AGENDA
City of Gig Harbor Design Review Board
Virtual Meeting of February 11, 2021

**COMMUNITY DEVELOPMENT DEPARTMENT
PLANNING DIVISION
STAFF REPORT**

RE: Skansie Mini Storage (PL-SPR-19-0010, PL-CUP-19-0002, PL-SEPA-19-0014, PL-DR-19-0088)
Public Meeting Date: February 11, 2021

**PLANNING DIVISION
DRB PRE-APPLICATION STAFF MEMO**

General Location of Trees

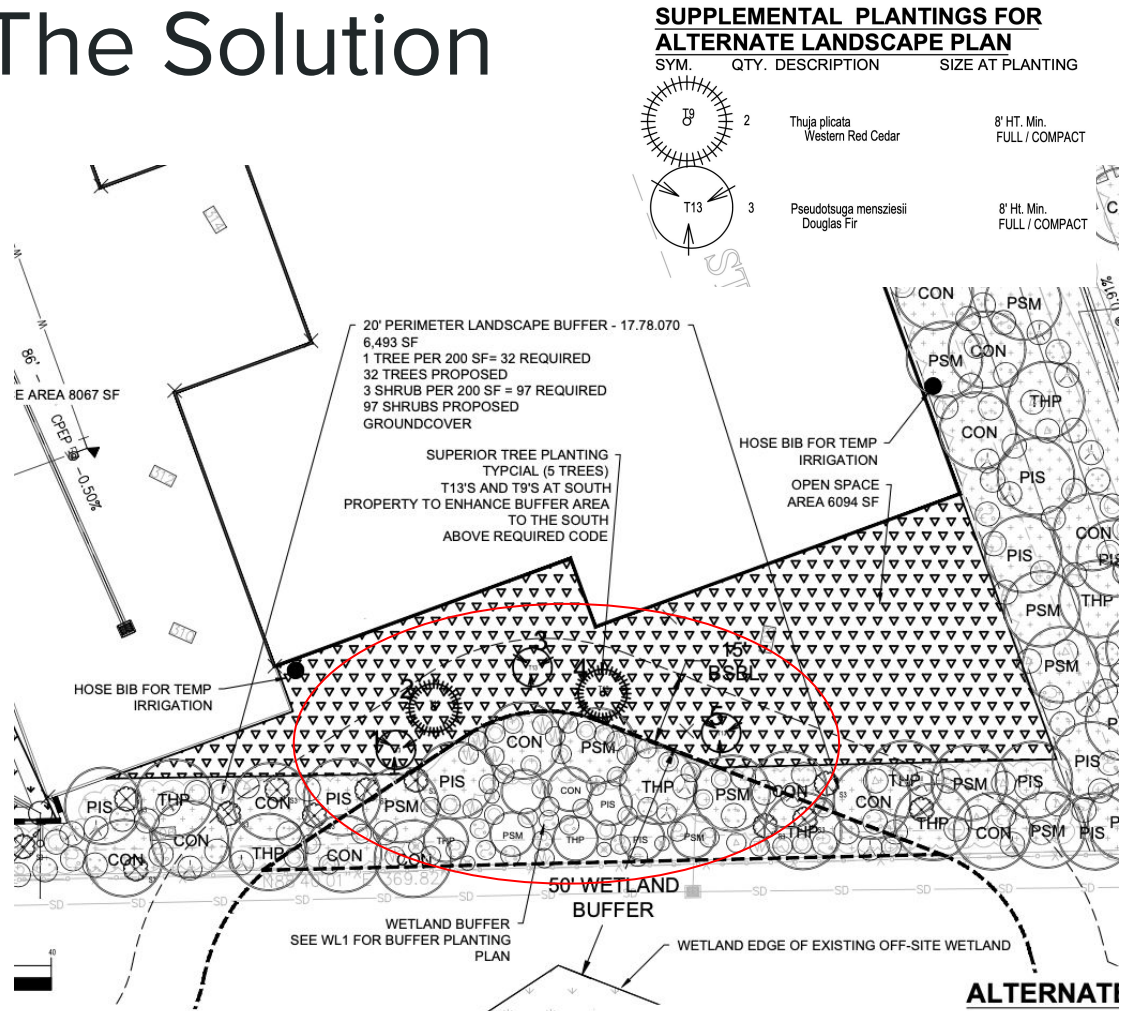
This is in response to my site visit to the property on the southwest corner of Skansie Ave & 89th St NW in June 2020. Trees #1,4,5,6 & 7 need to be removed because grading will be done for a retention pond where they currently stand. Tree #2 & 3 are just outside of where the grading will be done, although there is a retaining wall being installed in close proximity to the two trees. When this retaining wall is to be constructed, it is most likely about half of the root system of tree #2 & 3 will be severely damaged or removed in the process. Even if the trees were to survive this and kept growing, the stability of these trees would be extremely compromised. I recommend Tree #2 & 3 be removed along with #1, 4, 5, 6, & 7.

This has prompted us to create an (ALP) Alternative Landscape Plan that is superior to maintaining the existing 5 significant trees.

The proposed project will remove all seven (7) significant trees in the southwest area of the project site. The trees must be removed for storm facility installation and function. These trees have multiple trunks and are growing outward, which could potentially pose risk to the storm facility and fence.

Job Number
20693
Sheet
CWA2.1
of

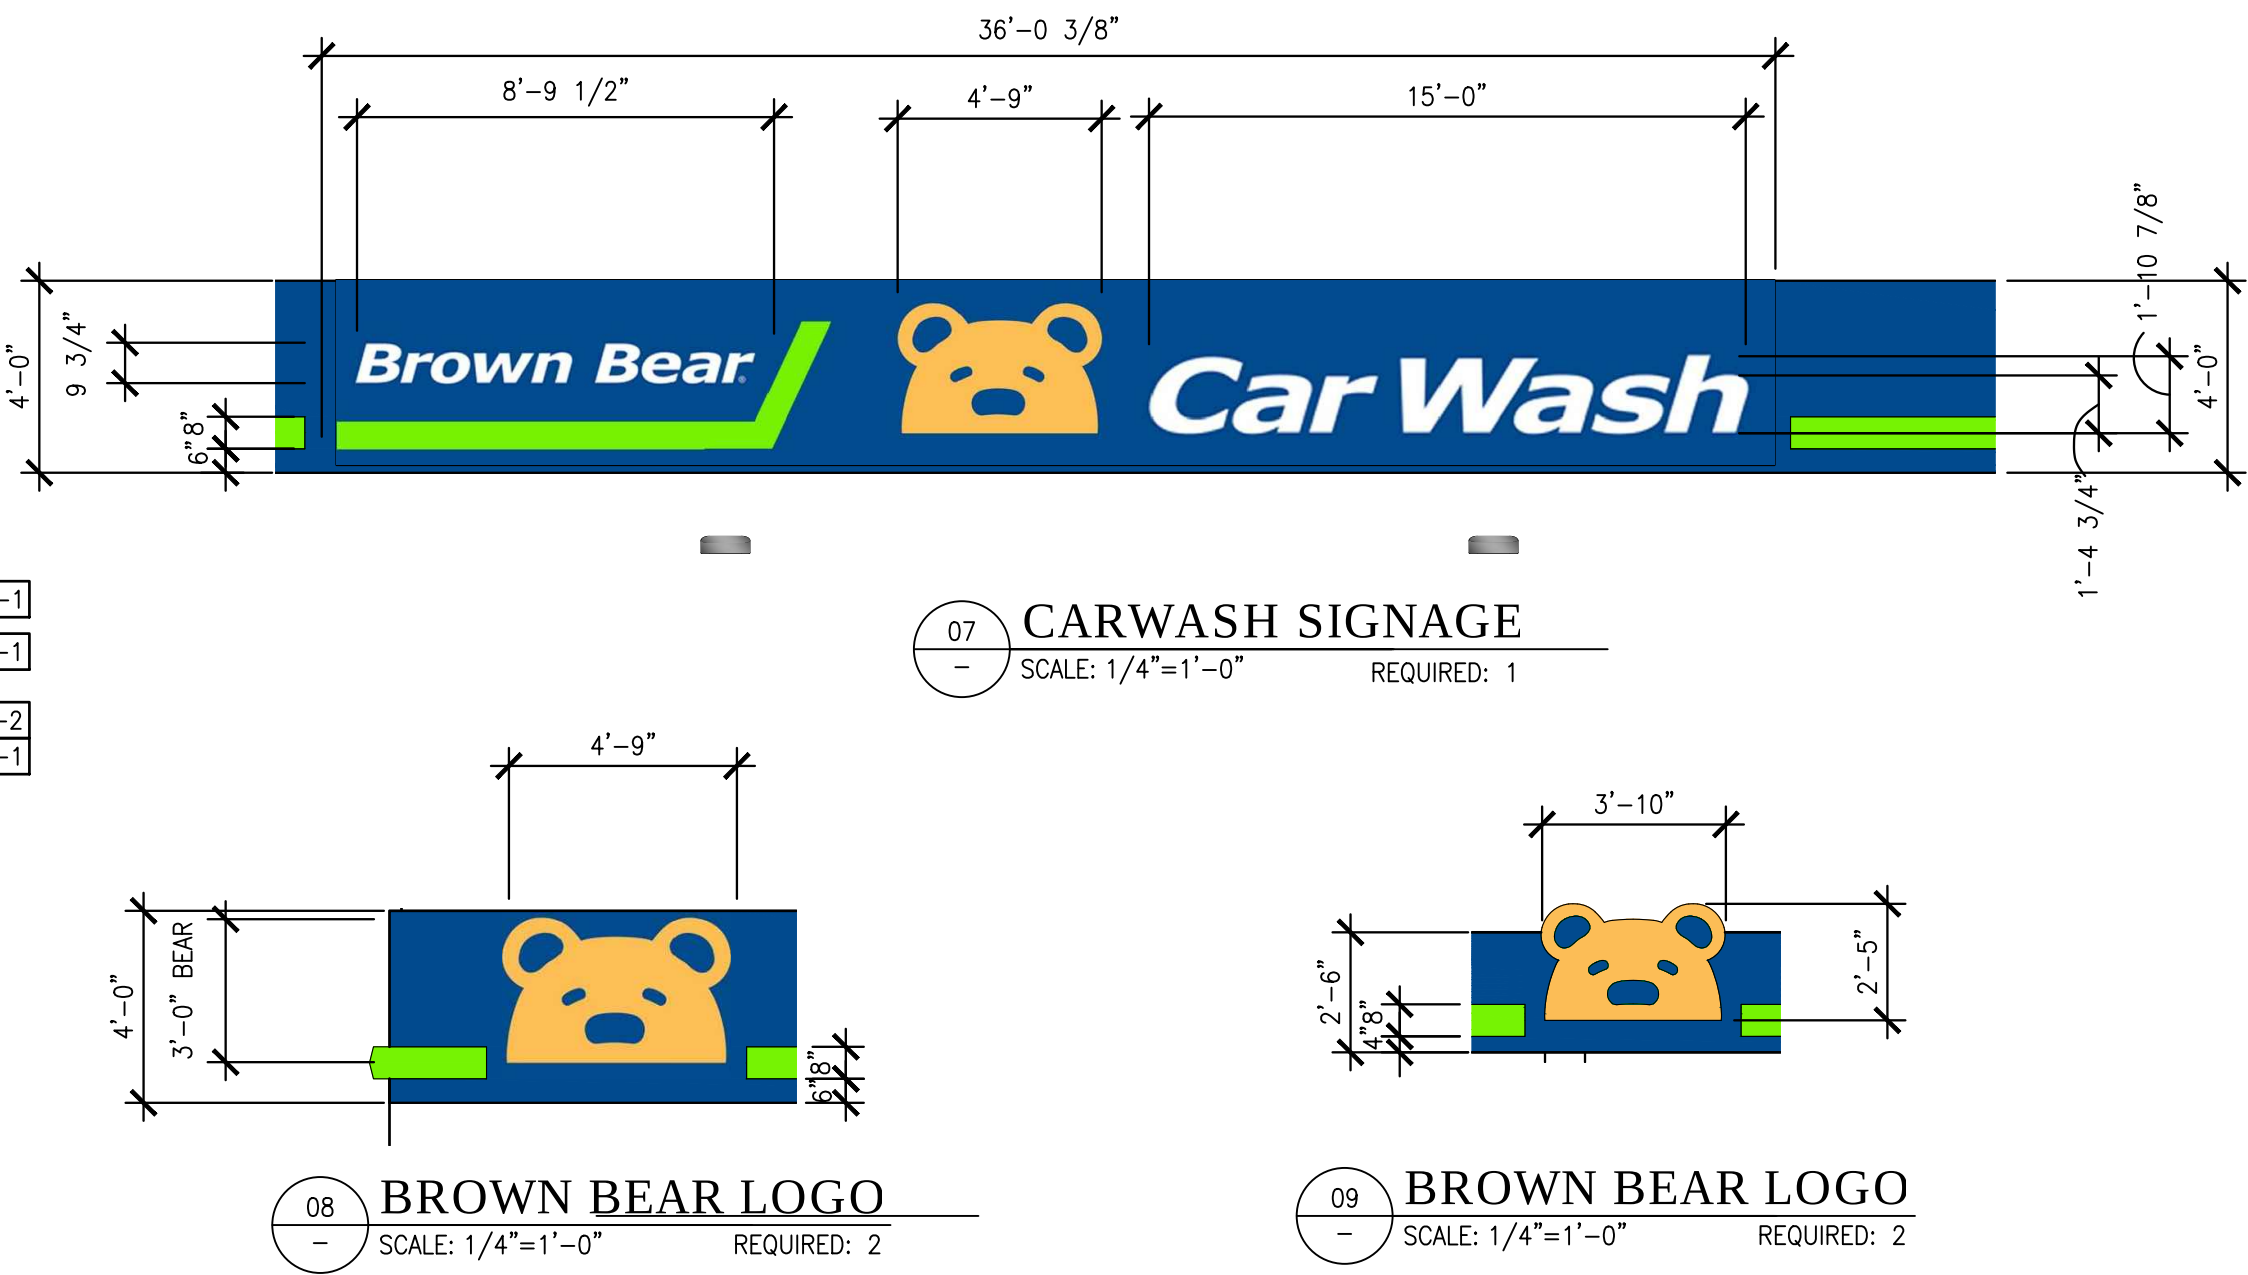
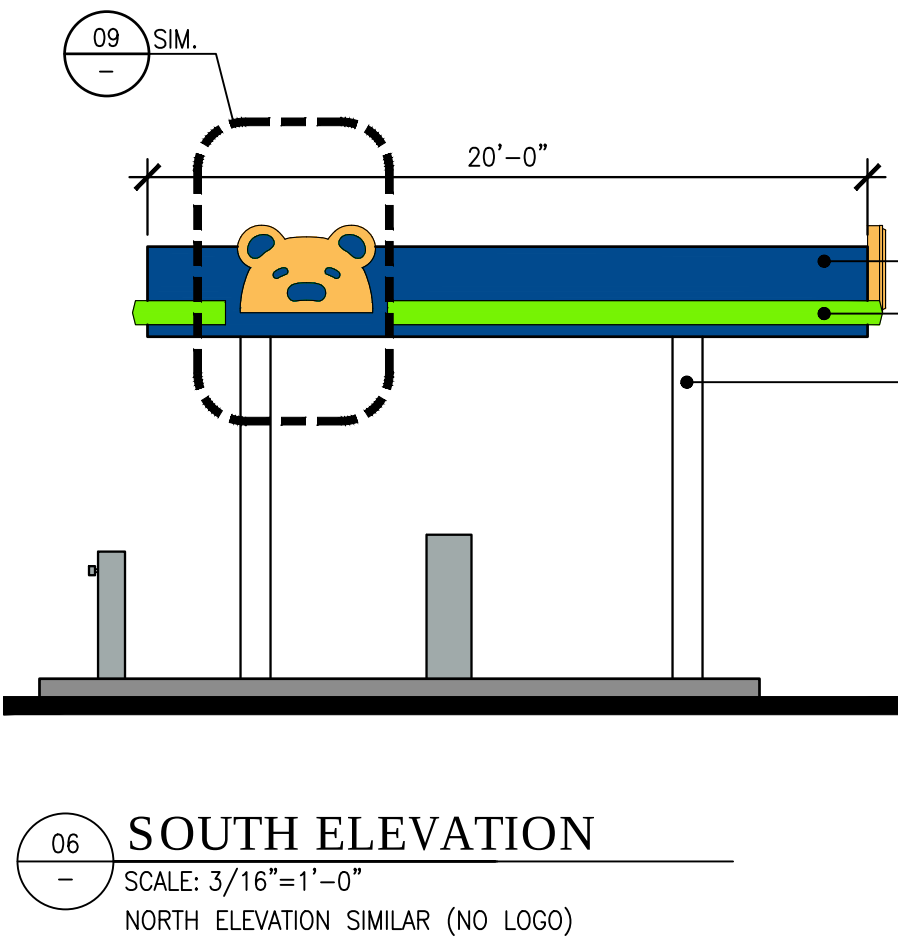
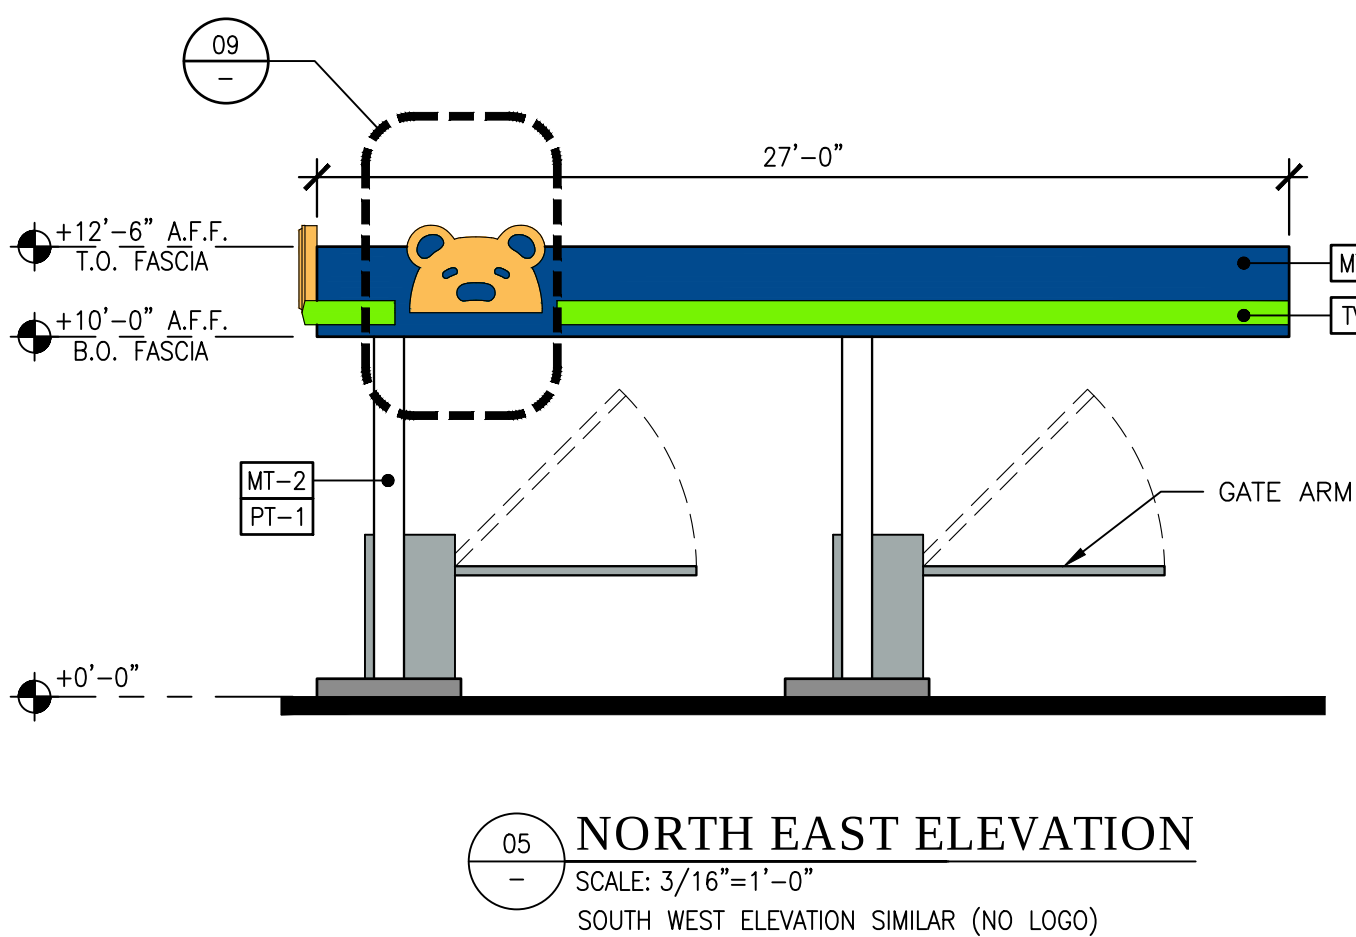
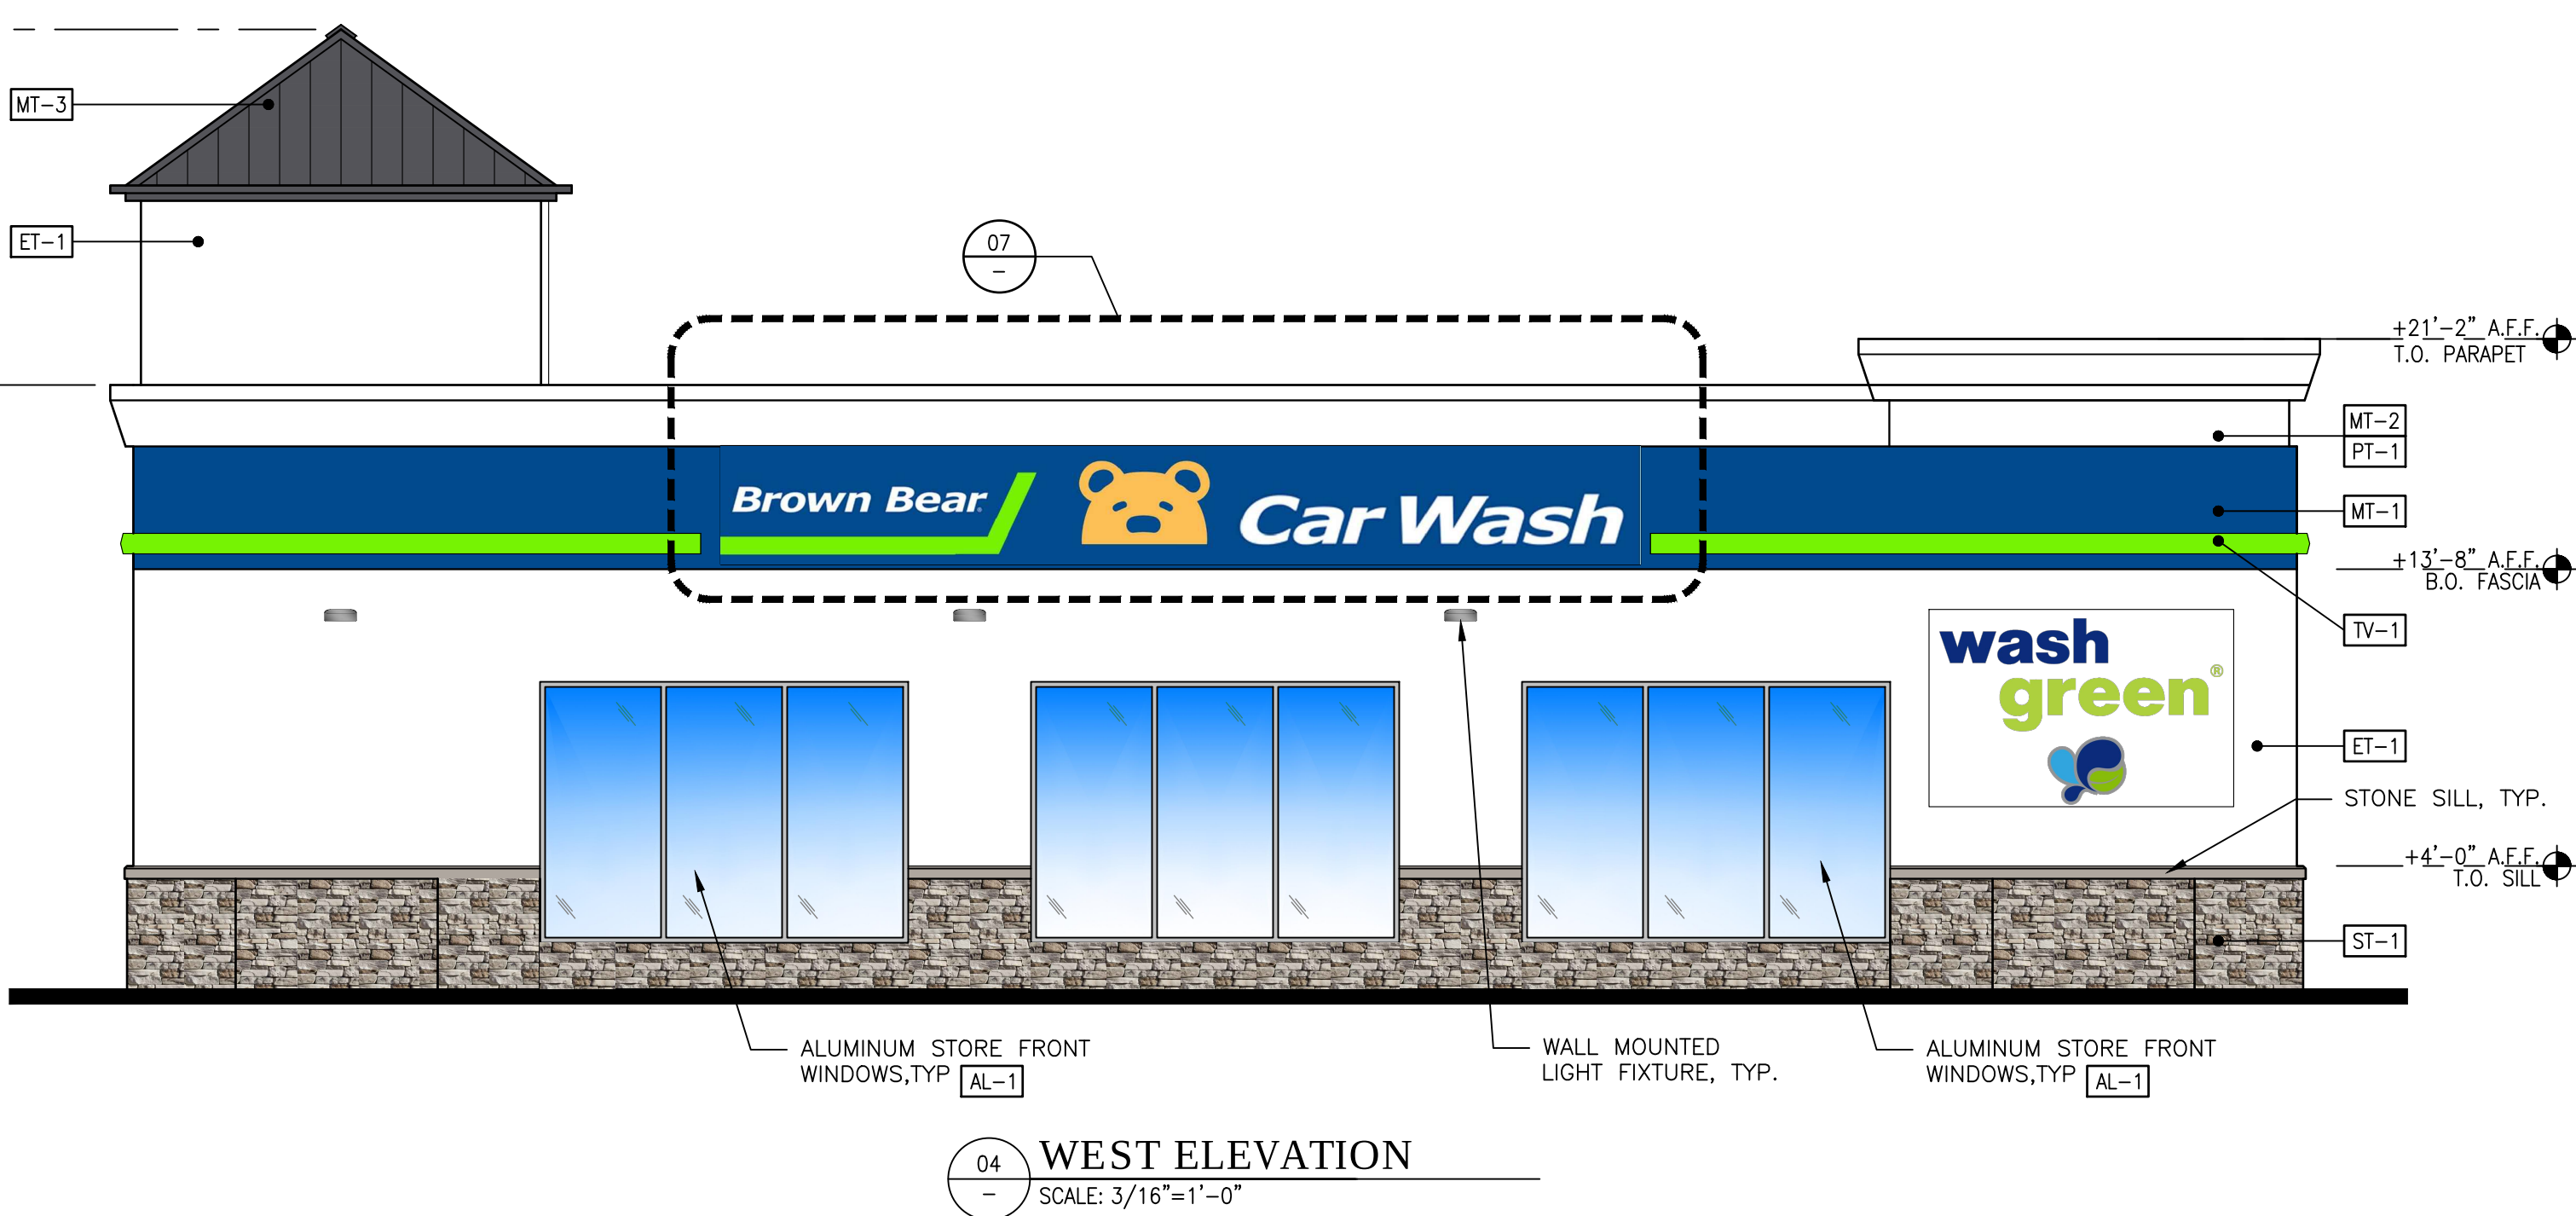
The proposed structure is 110 feet in length and 31 feet tall at its highest point with the majority of the wall plane for the proposed tunnel wash measuring approximately 20 feet in height. The length of the proposed structure exceeds the required limit of two and one-half times the height of the wall plane and no horizontal shift is proposed.

According to the applicant’s narrative, the proposed structure will include a “tower element” on the west elevation oriented to 32nd Avenue that will provide “articulation to the roofline.” However, the elevations provided by the applicant do appear to be consistent with the requirement of a vertical shift described in GHMC 17.99.380.B. The fascia appears to run in excess of 80 feet.
